GEORGE M.
JANES &
ASSOCIATES

RE: Comments related to Silo Ridge's
August 21, 2014 submission

Figure 1: Detail of the wall shown in C10-8 covering the eastern part of the water tank. It is approximately 12 by 100 feet and not shown on the site plans for the project, nor the visual simulations

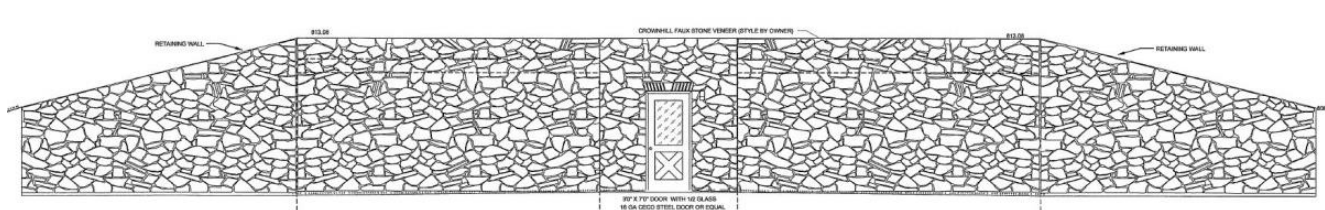
The site plan (sheet series C5) and the grading (C7) for the project do not match the plan for the water distribution system (C10.6), which shows a partially buried water tank, pump station, parking lot, circulation, and different grading, which does not match what is shown in C5 and C7. This is very serious for a number of reasons:

- C10.6 shows the water tank extending above grade with its eastern wall covered by a 12' by 100' retaining wall, which has a door to allow access to the tank. This is not shown on the visual simulations for the project.

- The Master Development Plan (MDP) for the project states that no retaining walls will be taller than six feet.
- If the grading done for the water distribution system is put in place, the Planning Board cannot know if it will work with the stormwater management system, which was designed for different grading.
- The tank is shown on what appears to be open space for the project, but impervious surfaces like the tank and the pump station (and related ancillary components) cannot be considered open space.

The applicant must integrate the plan for the water tank and distribution system into the plans for the site, redo the visual analysis (if the tank remains visible), redo the grading, and examine that new grading's impact on the stormwater management system.

Further, all ancillary components of the tank must be shown in addition to the pumping station. These components may include a generator, access ports, vent pipes for an underground propane tank, and other components. All components must be shown in a design not only in plan, but in the visual analysis for the project, especially considering the visual sensitivity of the location.

Figure 2: Detail of SP-04 from the MDP plans. Areas that are counted as open space, but which are not open space are marked

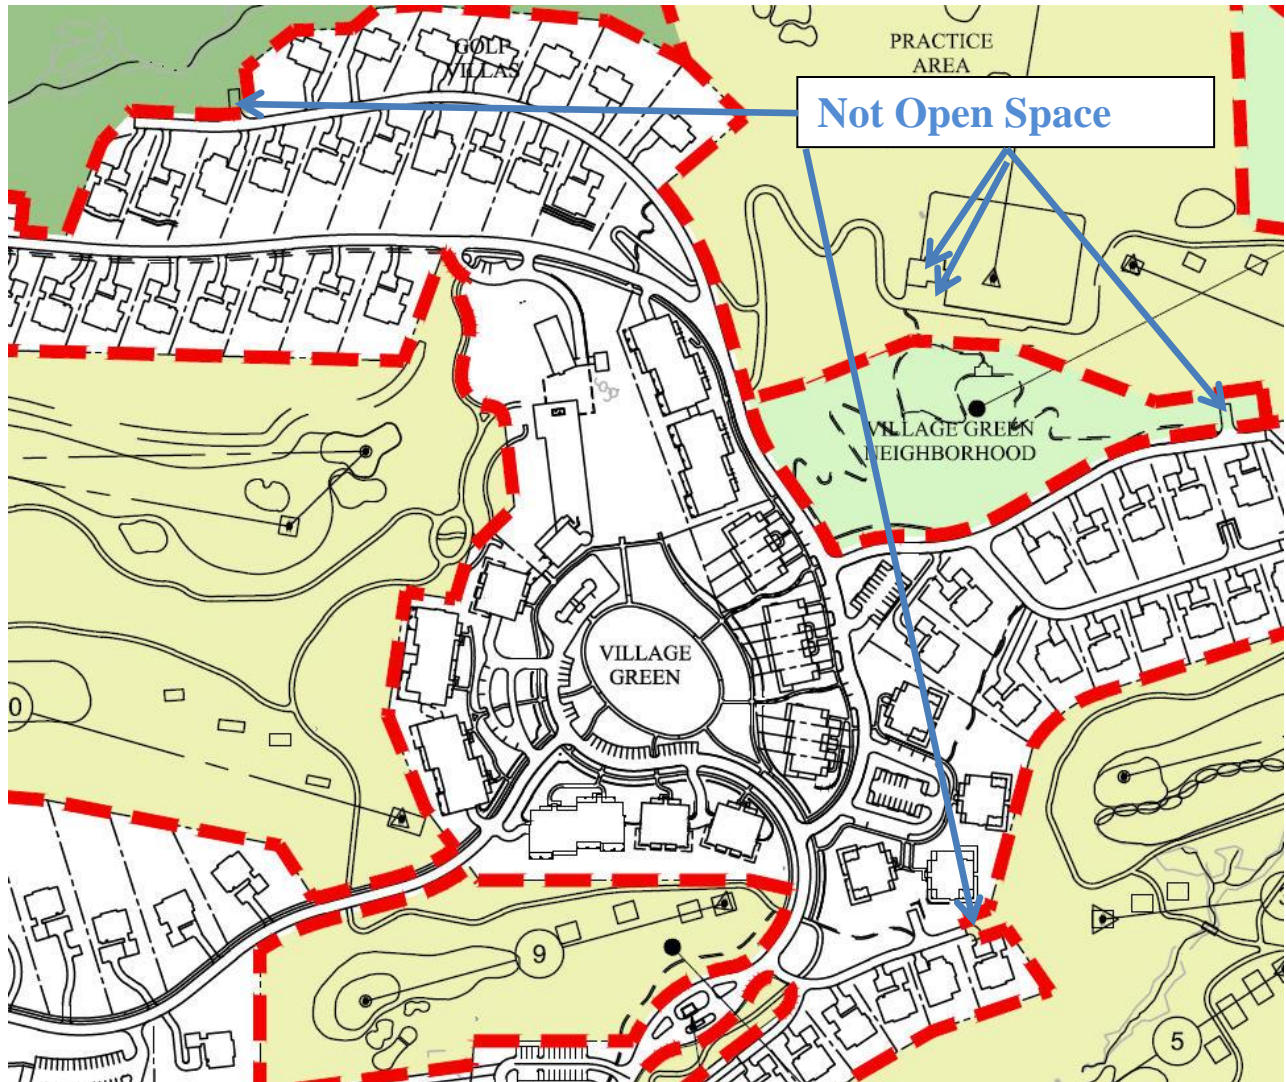
Open space for the project shown on SP-4 of the MDP Plans exceeds the 80% open space requirement by slightly over 1 acre. This calculation, however, includes some space that according to the Town's zoning should not be counted as open space.

The partially buried water tank, the pump station, and the related non-recreational paths and staircases used to service this infrastructure in the hairpin turn, are counted as open space, which clearly do not fit the definition that is in the definition of open space in the zoning code. Further, the golf academy building cannot be considered open space as it is a non-residential building over 200 SF. The impervious golf cart parking area around the golf academy and road hammerheads cannot be counted as open space. The following image identifies some of these smaller spaces counted as open space that should not be counted as open space:

At minimum, the applicant must redo the open space calculations excluding elements that should not be counted as open space. (The items identified above should not be considered exhaustive.) If the project no longer meets the 80% open space requirement, they could reexamine other spaces not currently classified as open space, which could potentially be counted as open space, such as the Village Green, or perhaps some of the wooded areas near the Phase 2 estate homes (see alternative design suggestions in Part 2.)

Figure 4: Detail of C7-08 showing the area being graded in yellow, with the implied height of some of the retaining walls called out

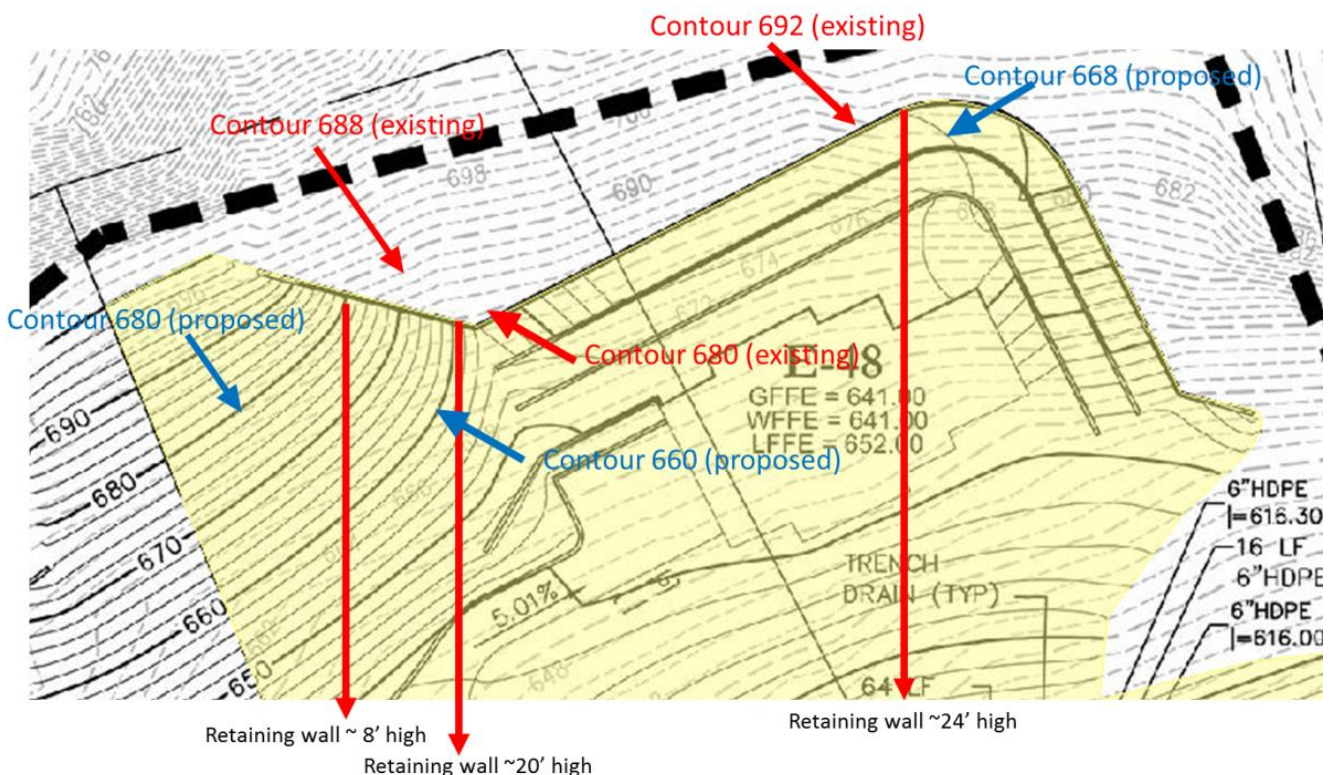
The project calls for some very tall retaining walls. I believe that many of the taller walls will need a railing of some kind for safety purposes and these railings are not shown on the site plans. Railings would need to be shown on plans. But more than this minor omission, the Planning Board should consider if these very tall walls should exist at all. For instance, examine the following detail from Lot E-48:

The implied height of the tallest retaining wall on this lot is measured in several places in the image above, and shows the wall is about 24 to 25 feet tall at its

tallest. This very tall wall is the last of three stacked retaining walls, which together cover about 40 feet in vertical elevation, which is taller than the proposed house.

Other issues with the retaining walls can be seen on the wall detail (S1.01), which only shows walls at a maximum of 11 feet. S1.01 should show the details for the tallest wall planned, which is at least 24 feet tall. Yet if this was done, the plans would be inconsistent with the Master Development Plan, which states that no retaining walls will be taller than six feet. The MDP, S1.01 and the C7 series all need to be made consistent.

The Board may want to consider some options that would allow the applicant to reduce the size of the retaining walls:

- If the area of disturbance is being minimized to meet the 30,000 clearing requirement of the SPO, the Planning Board may wish to consider waiving this requirement if the result is 40 vertical feet of retaining wall if these walls may be reduced by allowing more disturbance on the lot. This is a trade-off that should be considered carefully, however, and only as a last resort.
- More appropriately, the Planning Board should encourage the applicant to develop house designs that are more sensitive to changing topography, as directed by the Town's Rural Siting Guidelines (§121-31.G.) The lot for R-48 is for a house with one floor built into the hillside, with a small flat rear yard. A different design could build two or three floors into the hillside and allow for a sloping rear yard. The following is a section of a house that is designed for a steep hillside:²

- Encourage the applicant to consider more compact design that would allow difficult sites like E-48, which requires 40 vertical feet and 850 linear feet of retaining wall, to be left unbuilt.

Figure 6: Detail of C3-08 on the left with the same area of C7-08 on the right. The circled area shows an area that will be developed where the tree survey did not cover. There is mature forest in the circled area

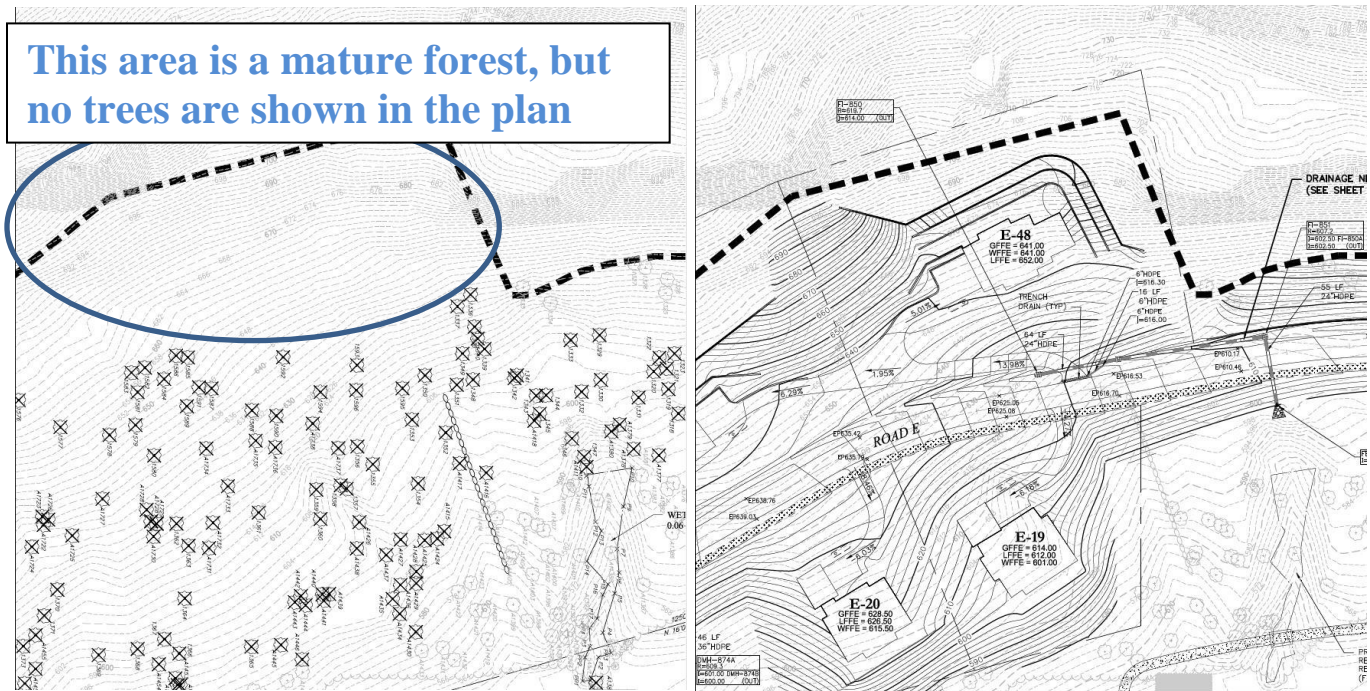
The boundary for the tree survey ends before the development does. The result is that heavily forested areas on the demolition survey are shown as if they have no trees or tree removal. For instance, consider the following details for the area around E-48:

The image on the left shows the demolition plan for the existing trees on the site. The image on the right shows the grading plan and the houses for the same area. Mature forests cover the area where E-48 is planned, yet the tree survey shows that there are no trees beyond what would be the front yard. There are trees on this site and many of them will be cut. It appears that the tree survey also falls short in lots E-49, E-50, E-51, and E-53. The applicant must complete the tree survey.

Figure 8: Detail of L3-02 showing the thick landscaped screen planned for the lower portion of Route 44. The red “1” marks an area of existing forest that could be narrowed to allow for better views

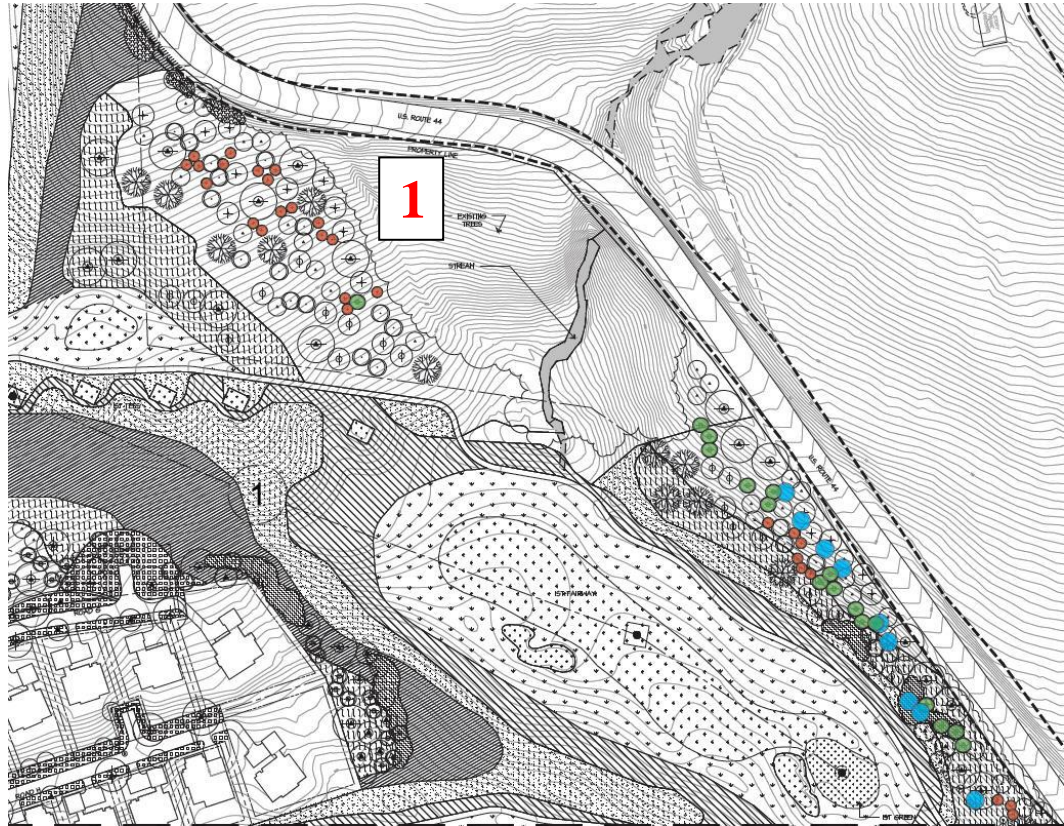
The Planning Board should consider requiring changes to the landscaping plan to preserve the views along Delavergne Hill. Currently, the plan calls for a thick vegetative buffer along much of Lake Amenia Road and Route 44 at the north end of the site. This buffer primarily screens the public view of the golf course. The golf course is a part of the 80% open space requirement of the RDO; as such it should be considered an attractive element and views to it should be enhanced, not blocked. As currently proposed, landscaping at the project edge will remove public views of this preserved open space. For instance, consider the following detail from L3-02:⁶

With a vegetative buffer of between 100 and 200 feet planned for the southern roadside of Route 44, the public will effectively have no view of the golf course from this part of the roadway. The next detail shows this buffer continuing along Route 44 and Lake Amenia Road, abated only for the utility easement and sensitive archeological area.

Further, the Planning Board may wish to ask the applicant to cut some of the existing trees near the "1" label in Figure 7 above, outside a 100 foot buffer of the stream that runs through that woodland, as these have grown over time, and such clearing would open up views of the golf course. The cleared area could then be converted to a meadow or lawn. The Town's code states that activities in the

Figure 9: Detail of L3-01 showing the thick landscaped screen planned for the lower portion of Route 44 and Lake Amenia Road

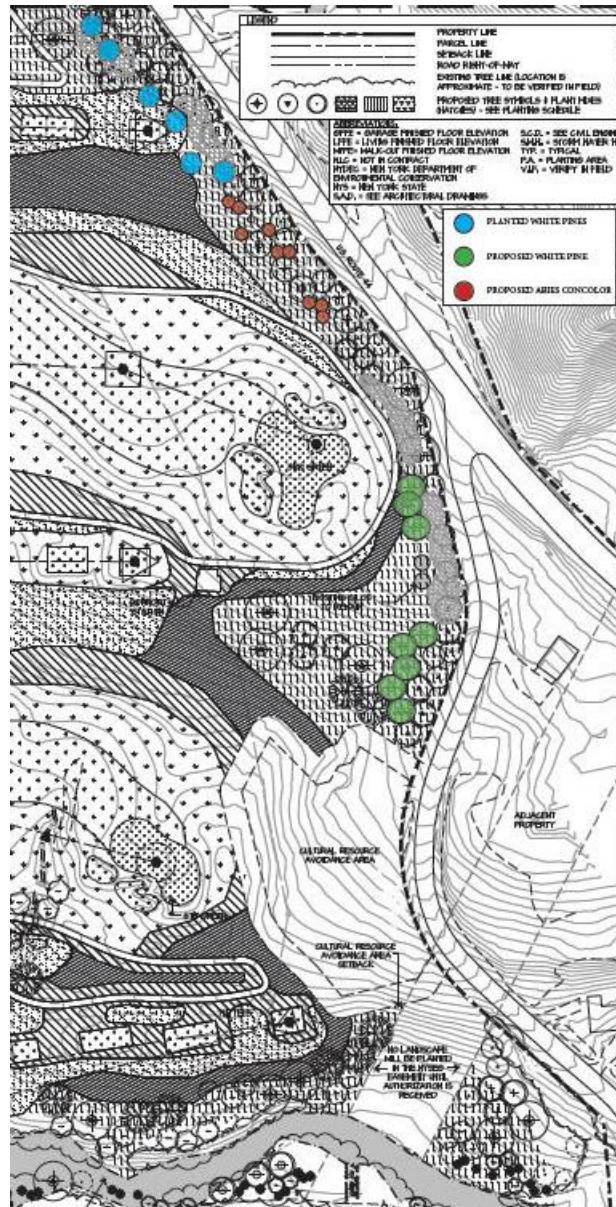
While these trees will screen some views of buildings, they primarily screen views to the golf course. I recommend that this area be left completely open, as meadow or lawn so that the view to the golf course is maintained and since any buildings they would screen would be far in the distance.

Figure 10: Detail of L3-02 showing part of the edge of the Village Green neighborhood

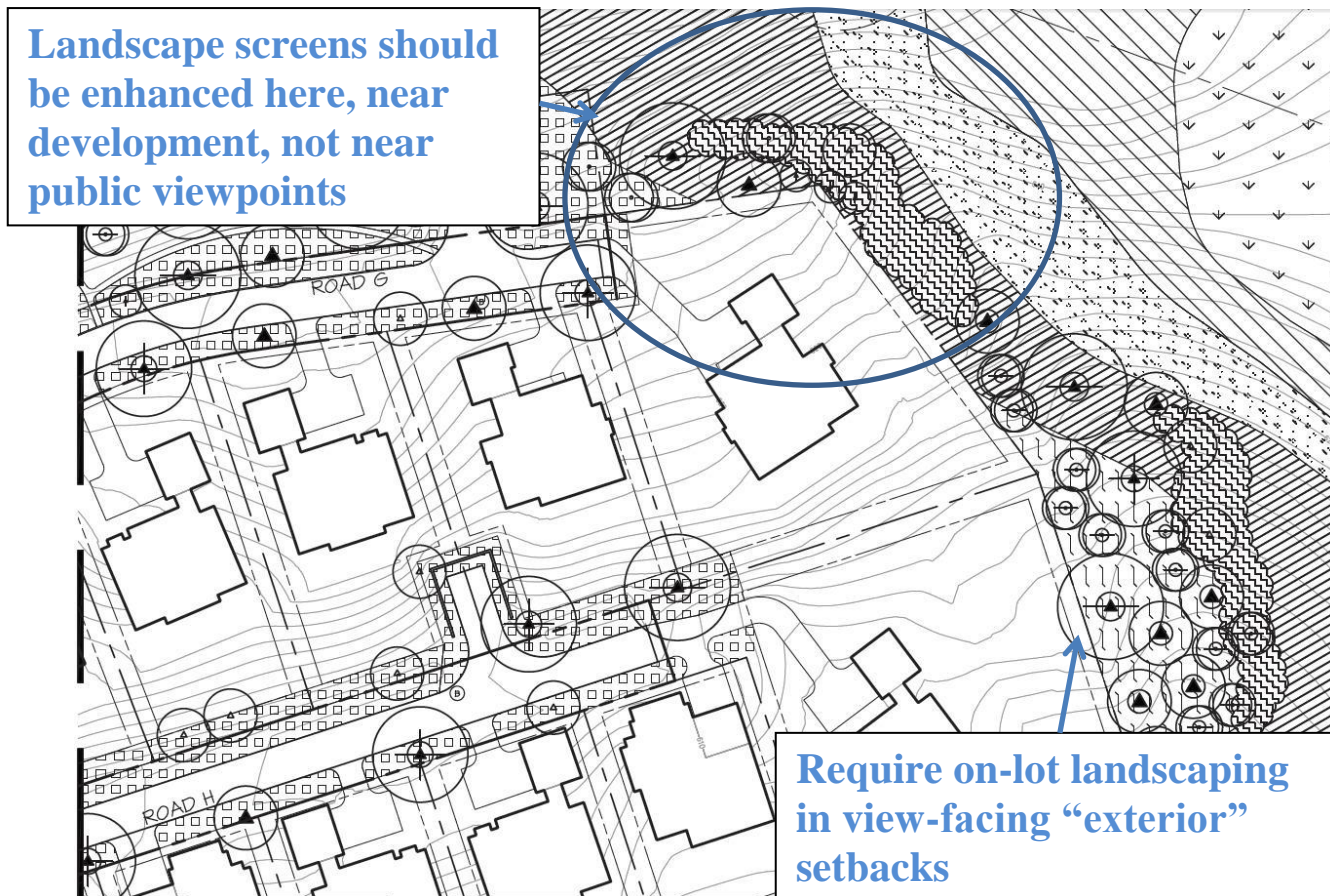
- Reconsider the landscaping planned for some of the edges of the development that face Delavergne Hill and Depot Hill. This concept is to remove screening from near to the viewer (the hedge and buffer along 44), and add screening to development far from the viewer, close to the on-site structures. While landscaping would be visually porous, it would soften the effect of development on the landscape. For example consider the following detail of L3-02, which shows the outer edge of the houses planned for the Village Green neighborhood:

In places at the edge of the development, like the portion circled above, the proposed landscaping thins. The landscape screens currently proposed for lower portion of Route 44 belong in locations like this. In some places the distance between the lot and the golf course is not large, but the planted area could be expanded if vegetative screens are required in all exterior⁸ setbacks. Enhanced landscaping closer to the development and further away from the viewer will keep the views expansive, and in most cases, at a much lower elevation.

This landscape screen can be designed to screen distant views, but could also be designed to allow views out from the homes to the golf course. Such a design would likely include trees with substantial canopies that would screen views to the houses from distant viewpoints, but with the lower limbs trimmed to allow ground level views outward.

Figure 11: Detail of L3-26 showing the Waste Water Treatment Plant with proposed landscaping

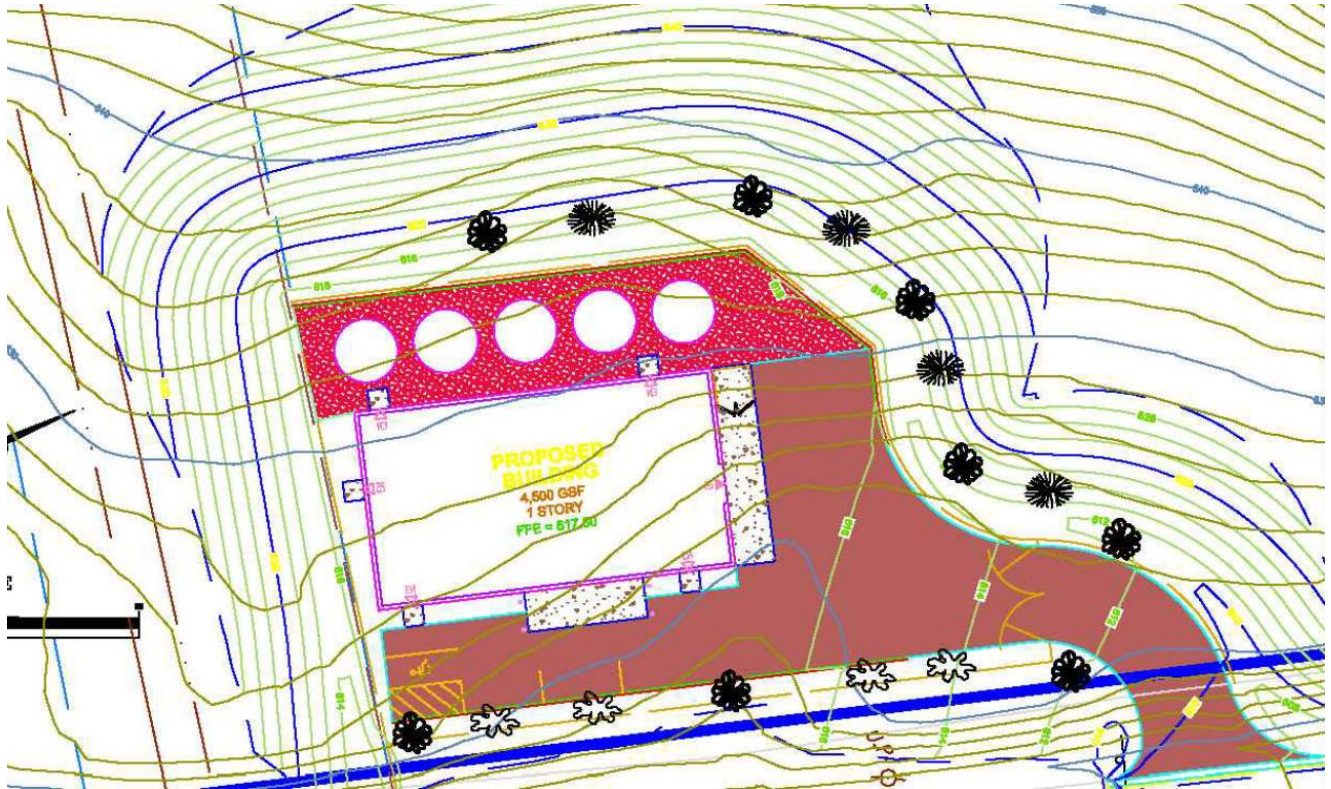
The landscaping around the Waste Water Treatment Plant (WWTP) is not adequate. While there are many views that should be kept open, the view to the WWTP is not one of them. The landscape plan shown as L3-26 shows a handful of small, widely spaced trees between the facility and the road, and no screening planned between the facility and the utility easement, which it abuts to the west.

The entire facility is in the Scenic Road portion of the SPO, and much of it is planned within the green buffer, for which the project needs a waiver. There are much better solutions for the Planning Board to consider for screening the facility.

A simple solution would be to increase the amount and kind of screening. The Board may wish to ask the applicant to consider a tall hedge which around the entire facility, which would be opaque and have the benefit of screening both the facility and the security fence.

I encourage the Planning Board to consider a more elegant solution, however; one which would involve rethinking how the site is graded and then landscaping around new grading. For instance, as currently proposed we see extensive site disturbance/grading and no retaining walls. This disturbance clears the wooded site in which the facility is planned and opens up lines of sight to the facility. A more visually sensitive design would instead develop a small earthen berm between the Route 44 and the parking lot, on top of which would have a thick

screening hedge, and behind which would be a security fence. The berm gives the hedge a larger effective screening height and may well provide some protection from the effect of road salts. Then, instead of severely grading the western, northern and eastern boundaries of the site as currently planned, the edge of the facility could be defined with a retaining wall. This wall would rise from zero to a maximum of about 20 feet in the rear of the facility. The security fence could sit atop the retaining wall and the hedge (or other screening vegetation) would not need to be very tall to screen views because of the added elevation. Such site design will preserve much of the existing mature vegetation, which will screen the facility along with the existing terrain, and would also remove the risk of grading within the utility easement, permission for which has not yet been demonstrated.
